**CITY OF FERNDALE
WASTEWATER TREATMENT PLANT UPGRADE**

**ADDENDUM NO. 3 (27 pages total)
Issue Date: December 20, 2019**

DRAWING S5.03

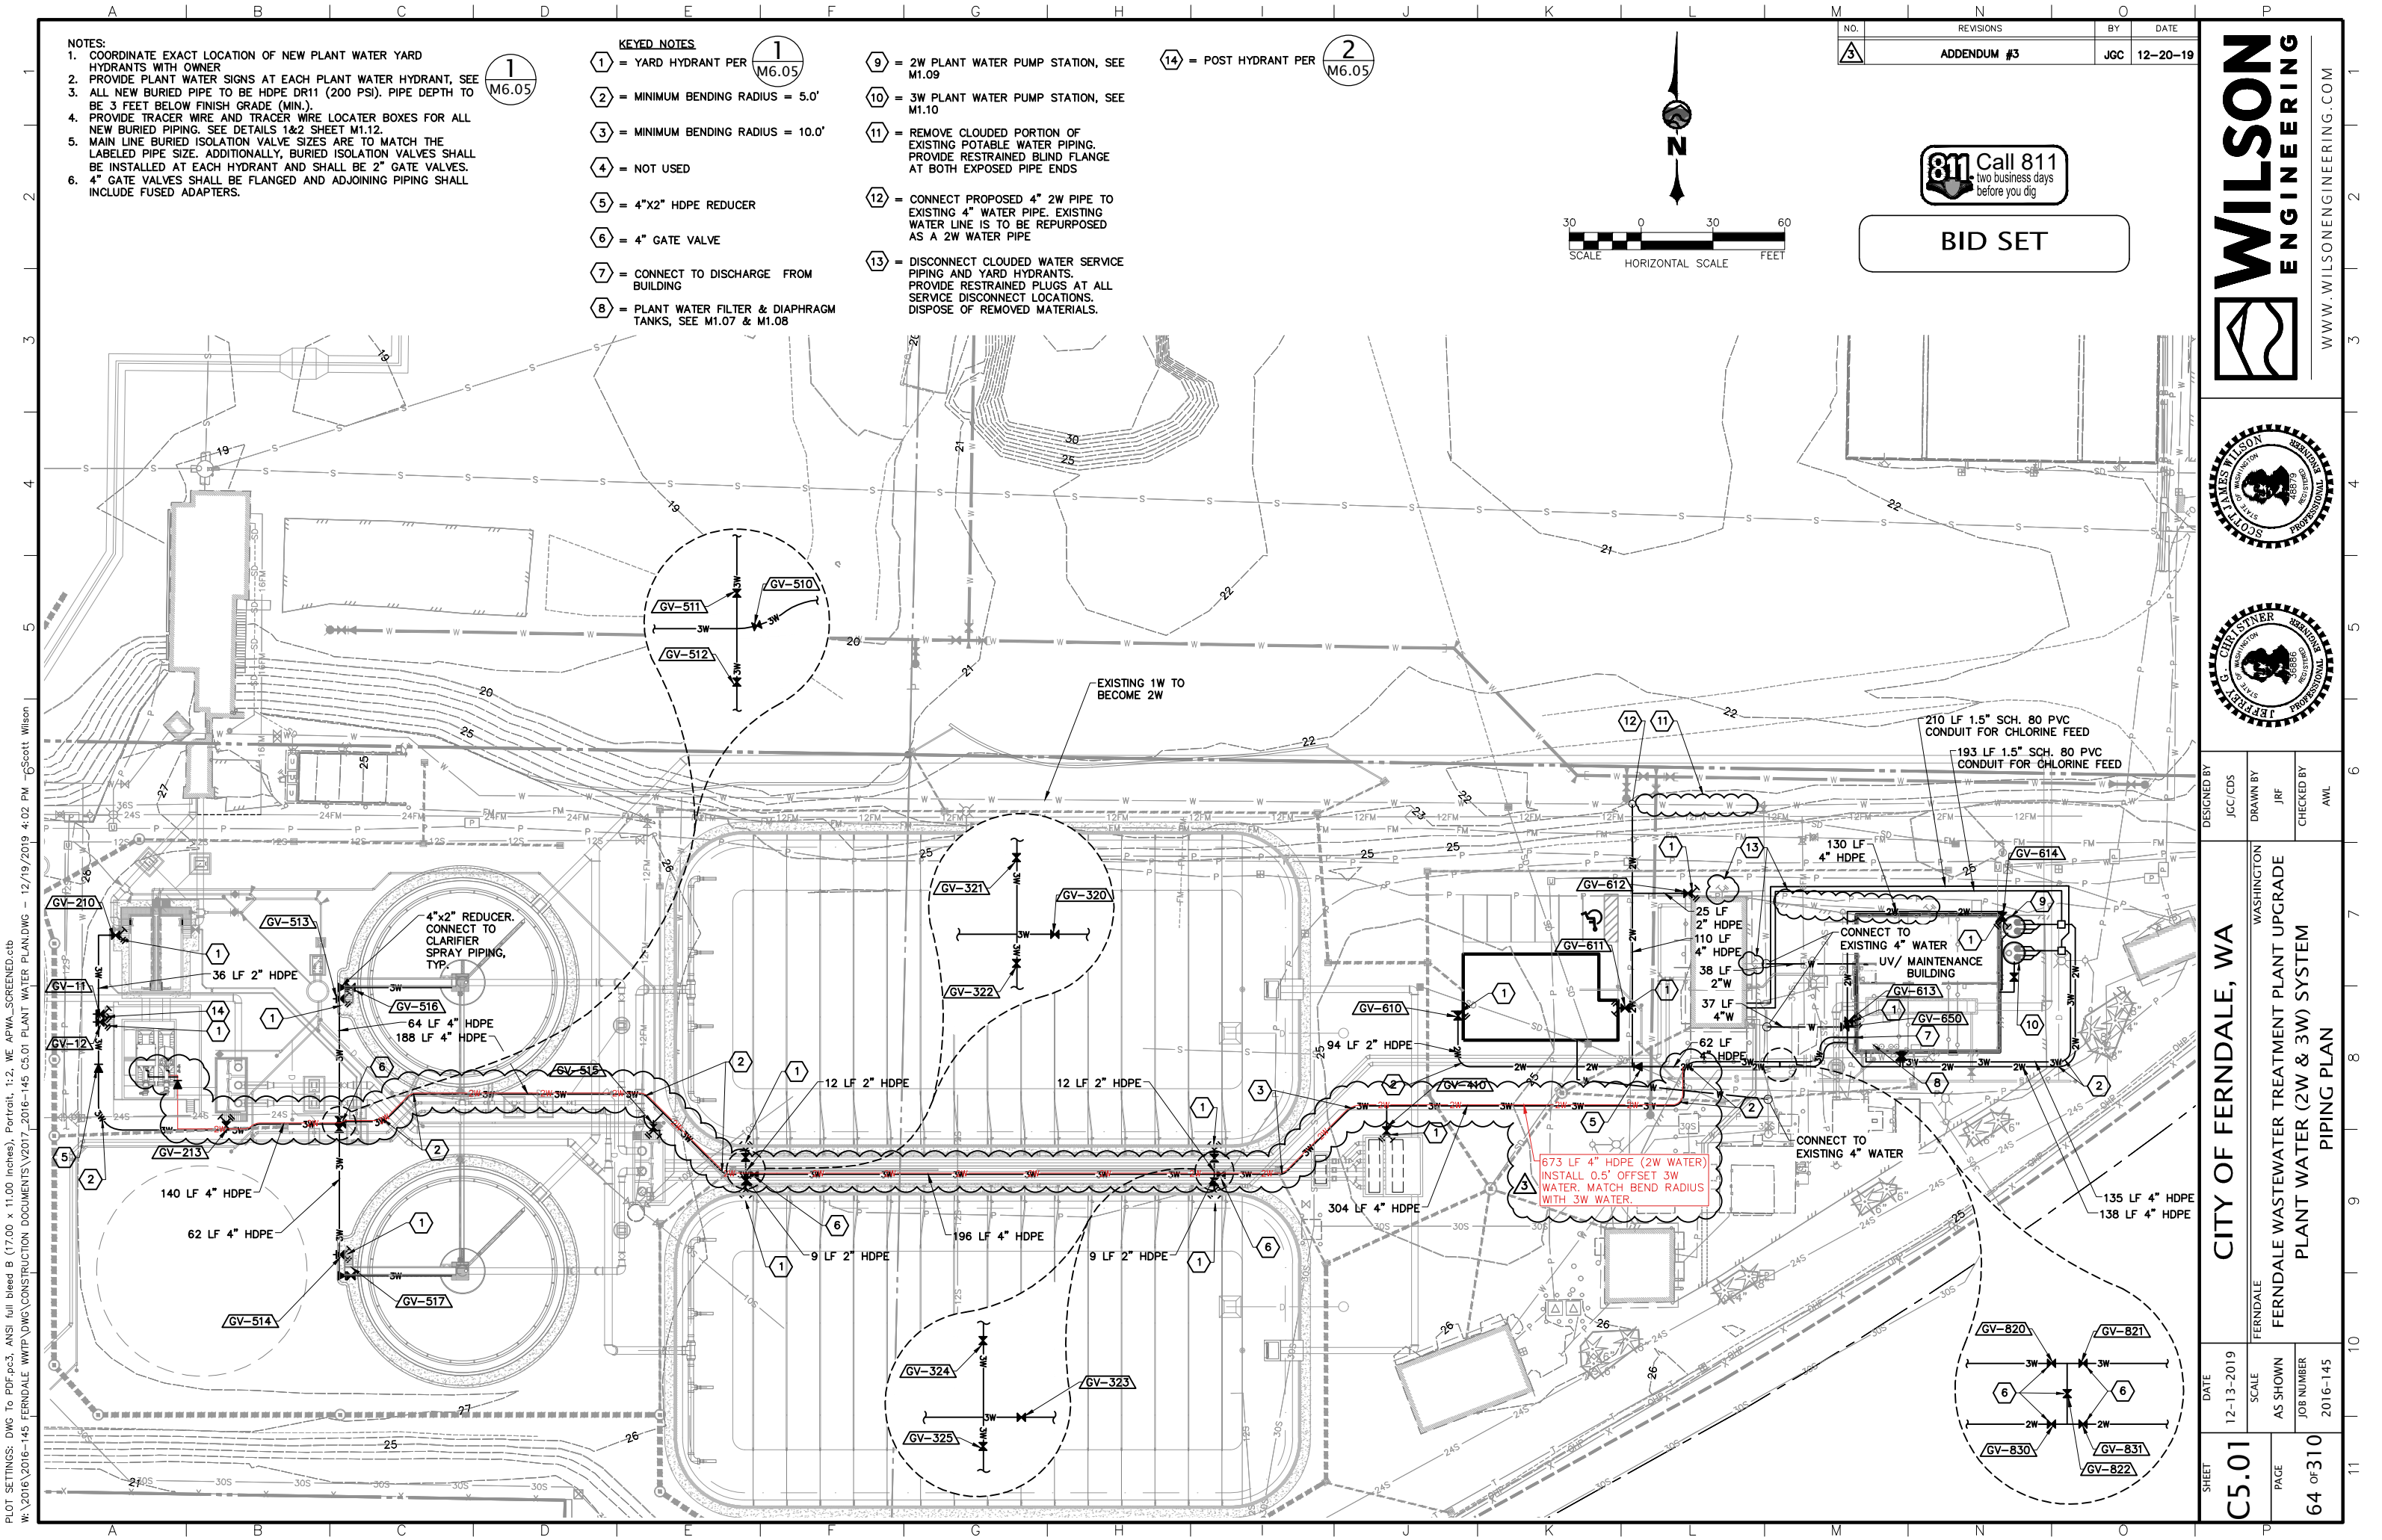
- **CHANGE:** All roof decking material shall be GALVANIZED per Spec 05 31 00, not aluminum. Headworks roofing shall be per detail section R2 on A0.01.
- **ADD** note #2: All bolts, nuts, and fasteners shall be 316 stainless steel.

DRAWING S5.04

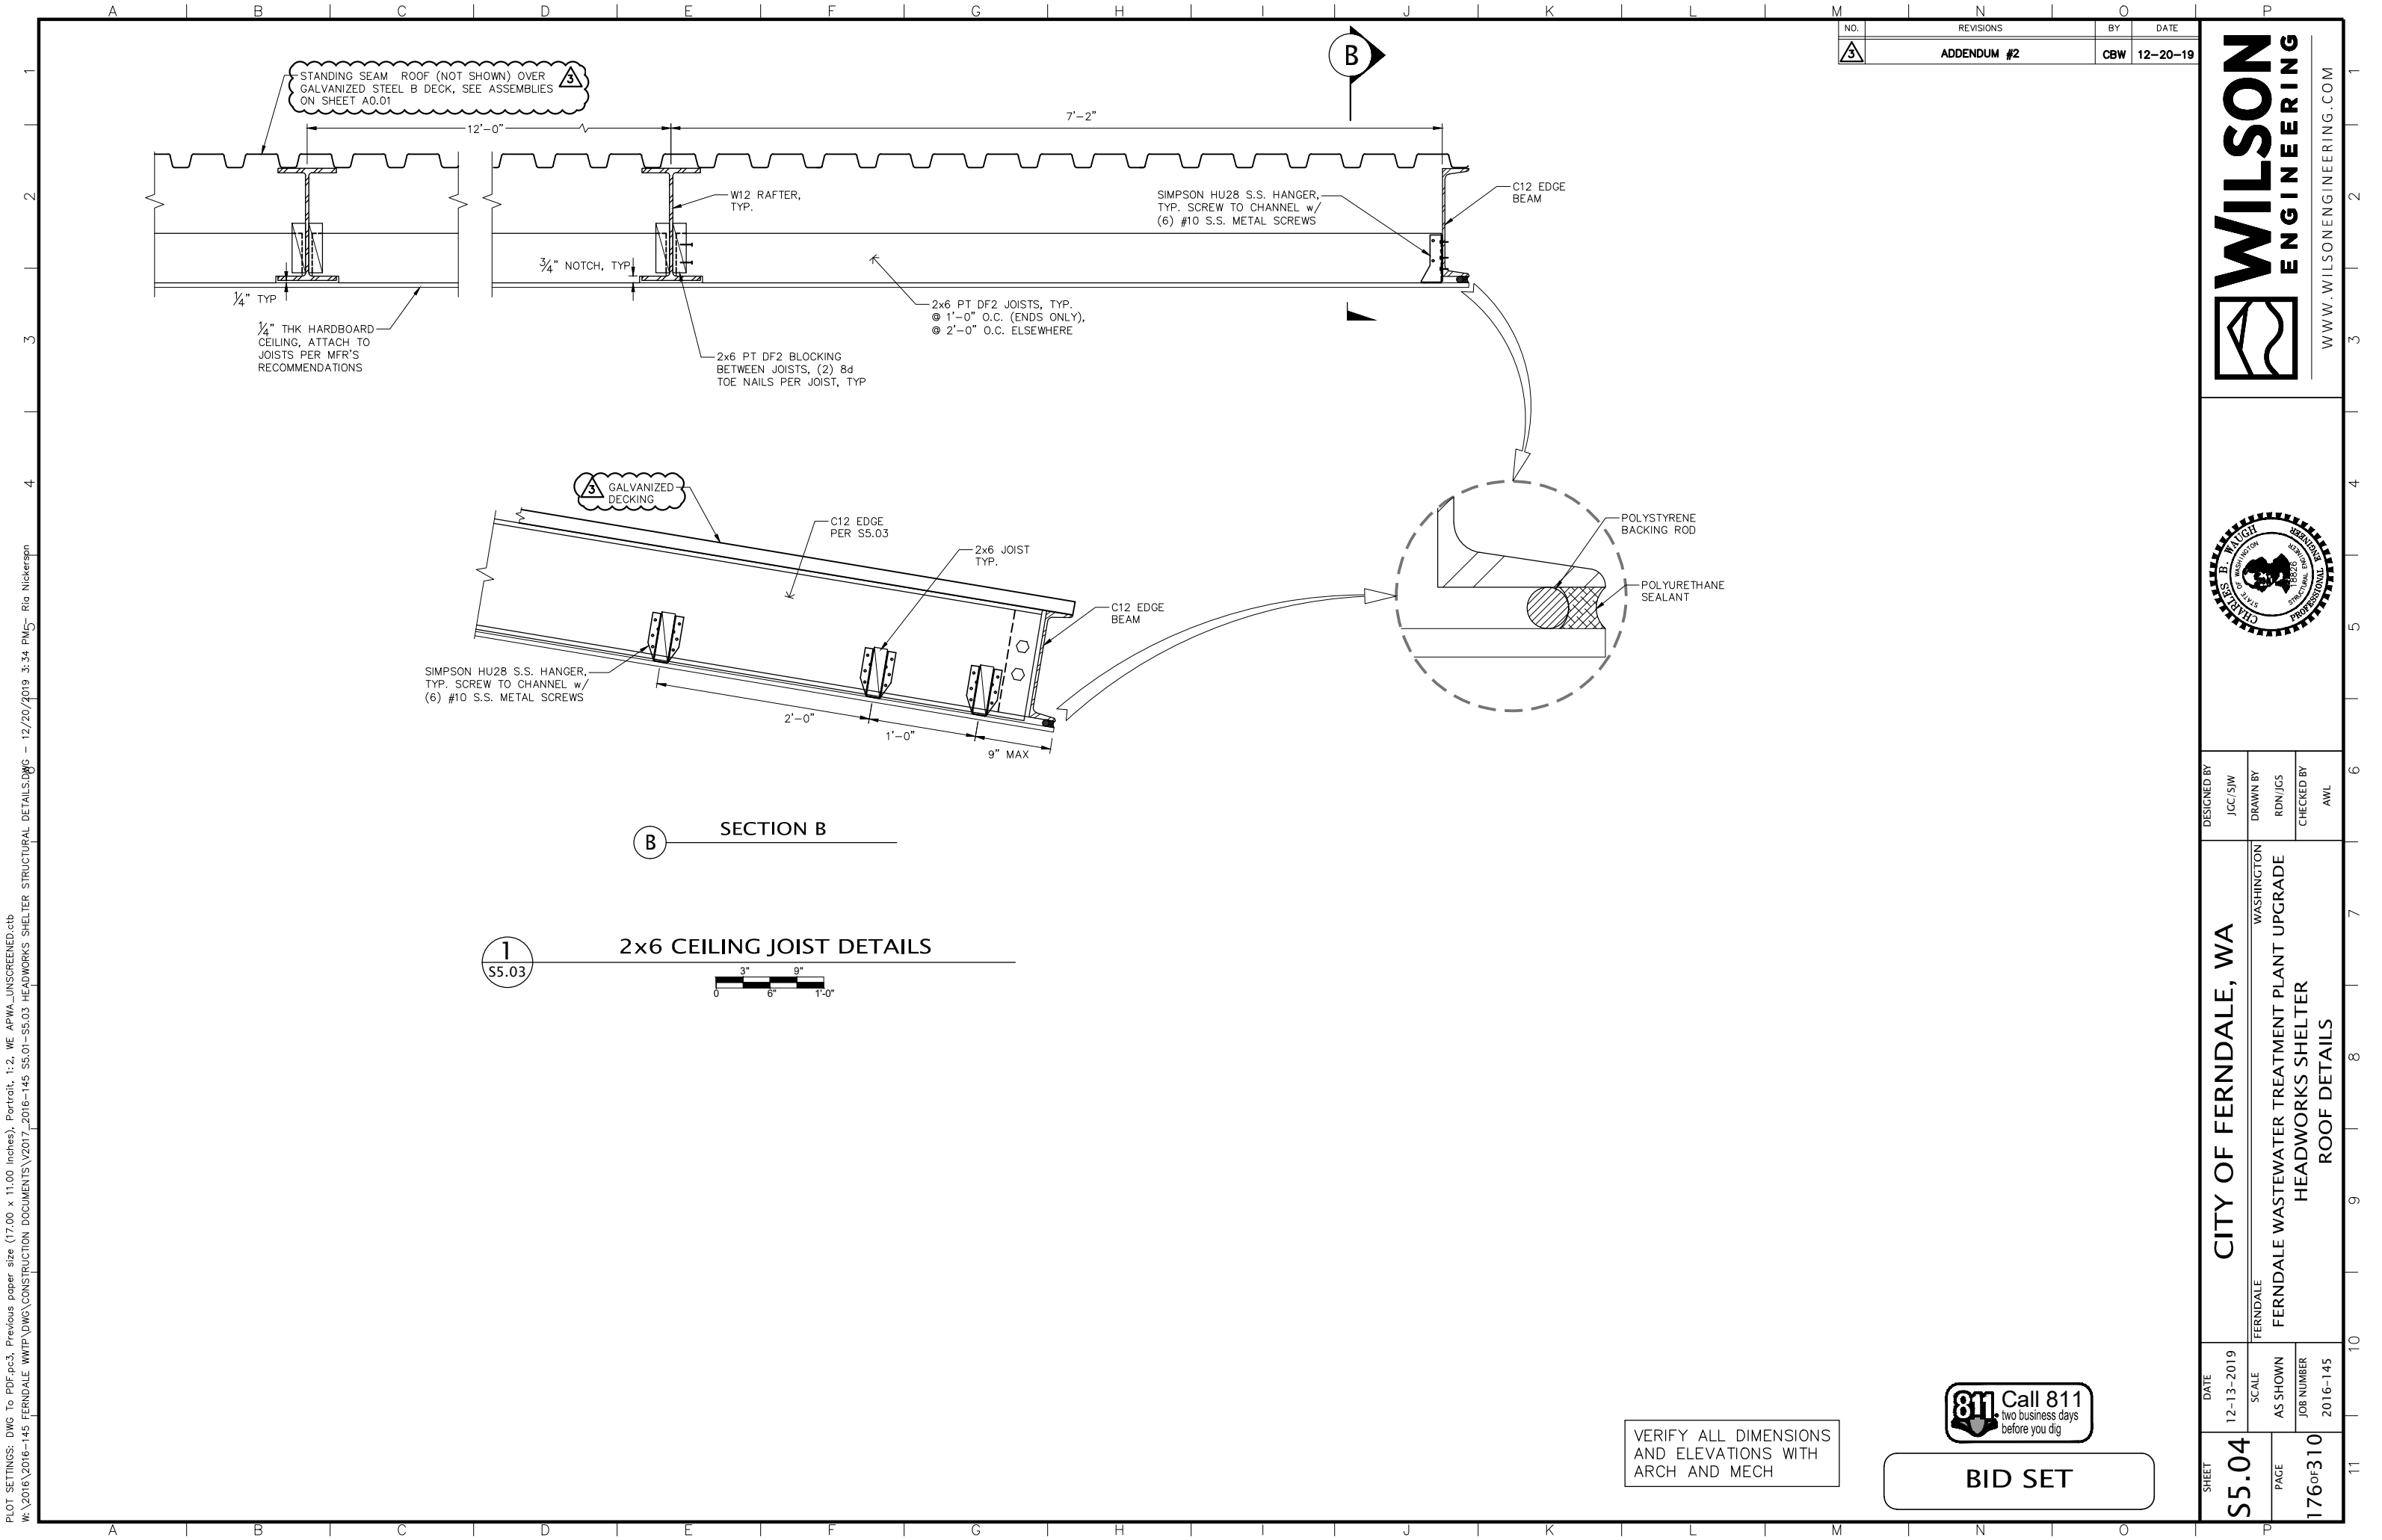
- **CHANGE:** All roof decking material shall be GALVANIZED per Spec 05 31 00, not aluminum. Headworks roofing shall be per detail section R2 on A0.01.
- **ADD** note: All bolts, nuts, and fasteners shall be 316 stainless steel.

SHEET E1.06A	DATE 12-20-2019	CITY OF FERNDALE, WA FERNDALE WASHINGTON FERNDALE WASTEWATER TREATMENT PLANT UPGRADE EXISTING HEADWORKS ELECTRICAL PLAN	DESIGNED BY BZ	WILSON ENGINEERING www.wilsonengineering.com
	SCALE AS SHOWN		DRAWN BY MM	
	JOB NUMBER 2016-145		CHECKED BY MM	
	PAGE OF

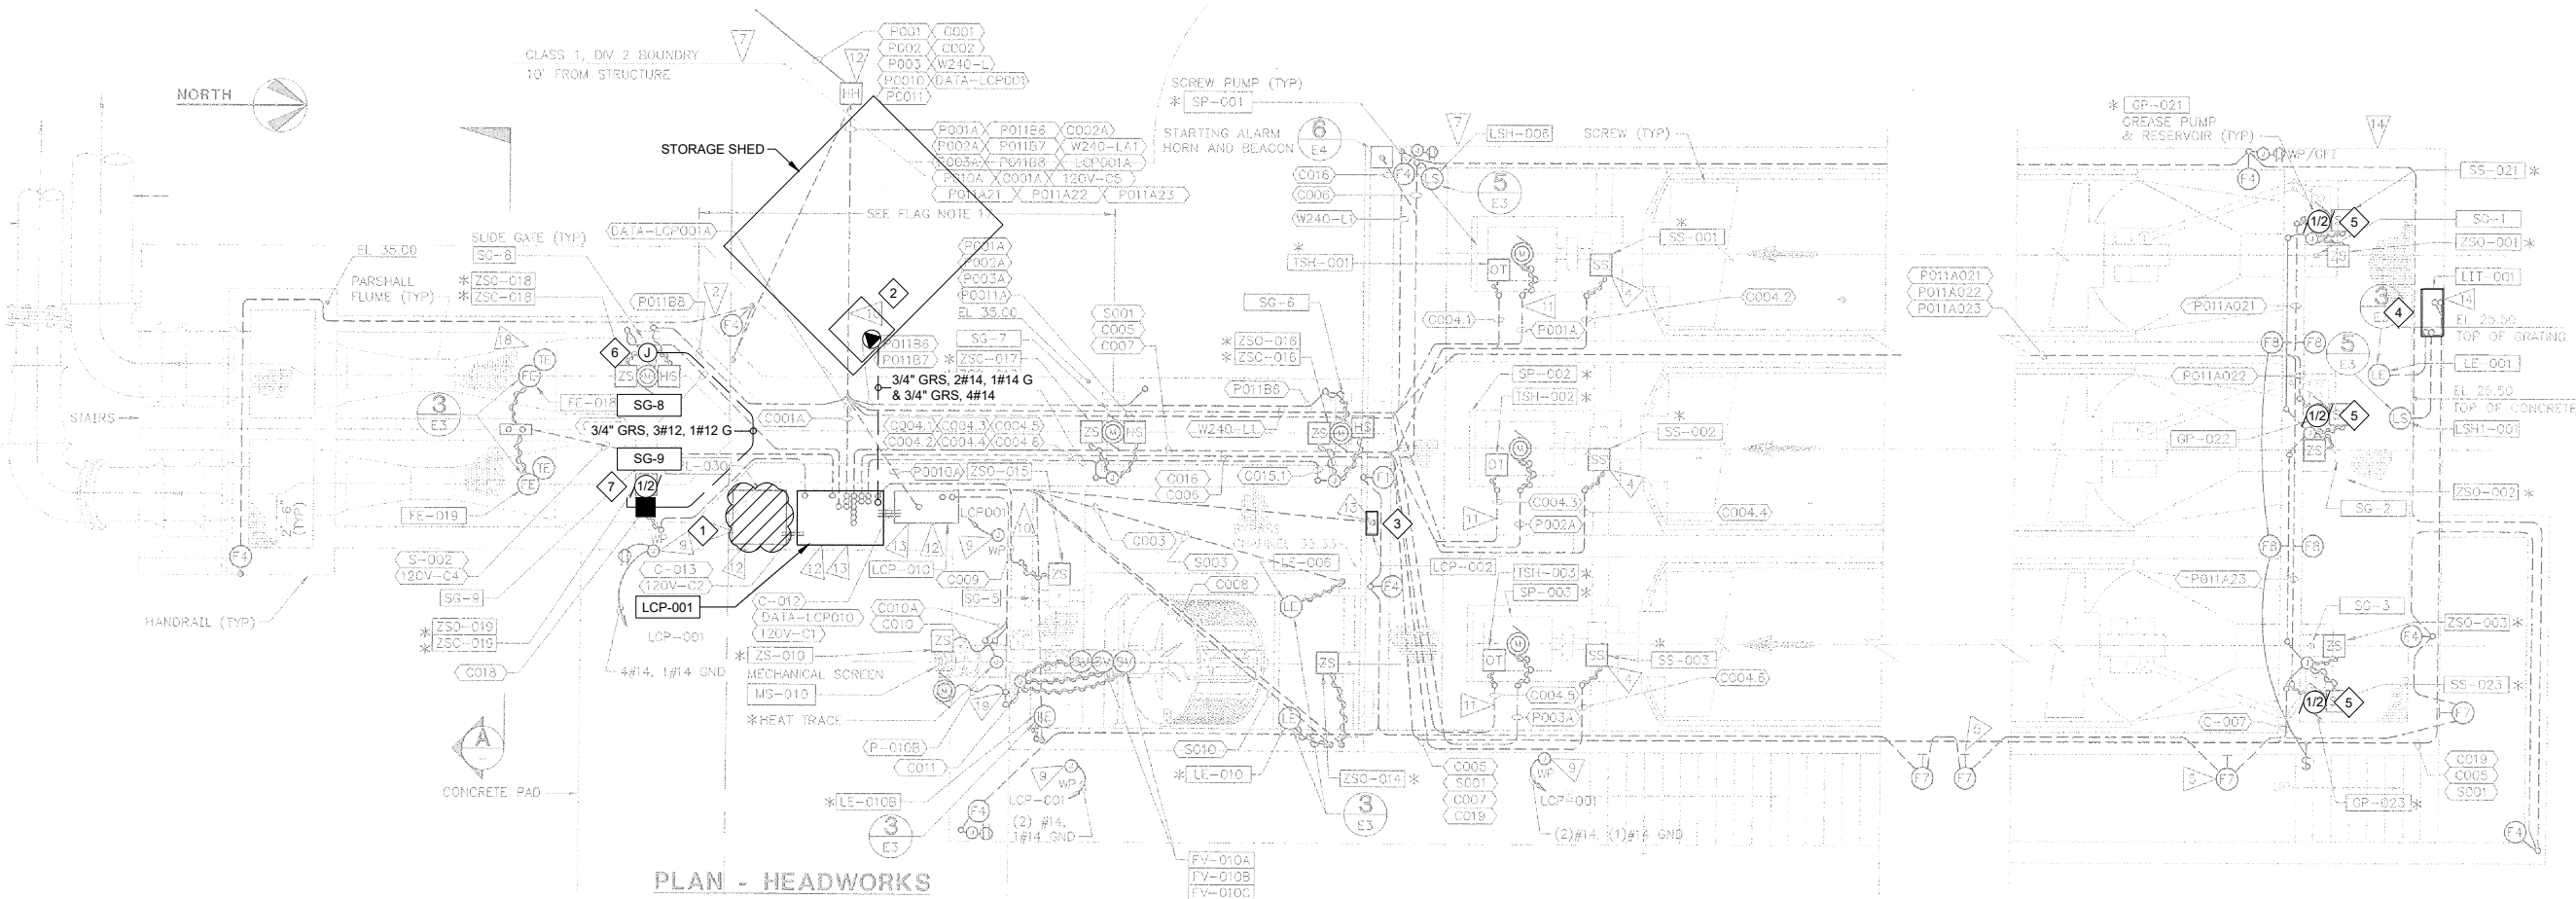
- **REPLACE** Drawing A0.01 with attached.
- **REPLACE** Drawing A2.02 with attached.
- **ADD** attached Drawing E1.06A to show required electrical work at existing Headworks.
- **REPLACE** Drawing E1.07 with attached. The drawing has been expanded to show the fiber routing to the existing Water Treatment Plant.
- **REPLACE** Drawing S3.02 with attached.
- **REPLACE** Drawing S5.03 with attached.
- **REPLACE** Drawing S5.04 with attached.

- 1 DEMOLISH EXISTING INFLUENT SAMPLER AND ALL ASSOCIATED CONDUITS AND CONDUCTORS.
- 2 PROVIDE NEW INFLUENT SAMPLER IN EXISTING STORAGE SHED. FIELD COORDINATE LOCATION WITH OWNER. NEW INFLUENT SAMPLER SHALL BE RE-CONNECTED TO THE EXISTING SAMPLER POWER AND CONTROL CIRCUITS IN LCP-001.

- 3 DEMOLISH AND REMOVE EXISTING LCP-002 SCREW PUMPS CONTROL PANEL. PROVIDE NEW NEMA 4X STAINLESS STEEL PANEL TO MATCH EXISTING AND RE-CONNECT TO EXISTING CIRCUITS.

- 4 DEMOLISH AND REMOVE EXISTING WETWELL LEVEL PANEL LT-001. PROVIDE NEW NEMA 4X STAINLESS STEEL PANEL TO MATCH EXISTING AND RE-CONNECT TO EXISTING CIRCUITS. CONTRACTOR SHALL RE-LOCATE EXISTING LEVEL TRANSMITTER TO NEW PANEL.

- 5 DEMOLISH AND REMOVE EXISTING GREASE PUMPS. PROVIDE NEW GREASE PUMPS AND RE-CONNECT TO EXISTING CIRCUITS.
- 6 CONTRACTOR SHALL INTERCEPT EXISTING SG-8 POWER CONDUIT AND INSTALL A NEW JUNCTION BOX. RE-CONNECT THE EXISTING WHIP TO SG-8 AND INSTALL NEW POWER CONDUIT AND CONDUCTORS TO SG-9.

- 7 CONTRACTOR SHALL PROVIDE NEW GATE ACTUATOR FOR SG-9 AND A NEW HAND SWITCH TO MATCH EXISTING ON SG-8. PROVIDE 5#14 AWG CONDUCTORS IN EXISTING CONTROL CONDUIT FOR THE NEW HAND SWITCH AND TERMINATE ON SPARE I/O IN LCP-001.
